**Subject** ▶ Change of Armature Assembly

**For Models** ▶ 9523NB, 9523NBH, 9524NB, 9525NB, 9526NB, 9526NBH, 9526PB, 9526PBH, 9527NB, 9527PB, 9528NB, 9528PB

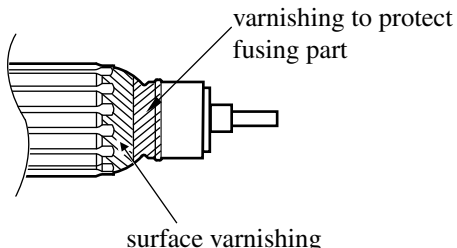
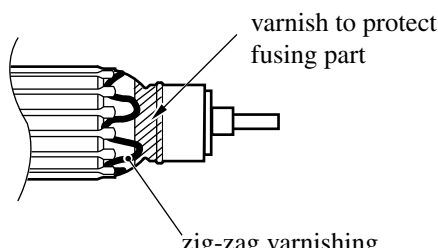
**Description** ▶ 1) The way of varnishing on Armature Assemblies have been changed as illustrated below.  
2) The following three armature assemblies without fan have been eliminated and replaced by those which include fan;  
Part No.510031-6 (100V), Part No.510032-4 (115V), Part No.510033-2 (220/240V)

▶ Current	▶ New
<p>Way of varnishing: Conventional varnish coating as illustrated below</p> 	<p>Way of varnishing: Zig-zag varnish coating as illustrated below</p>
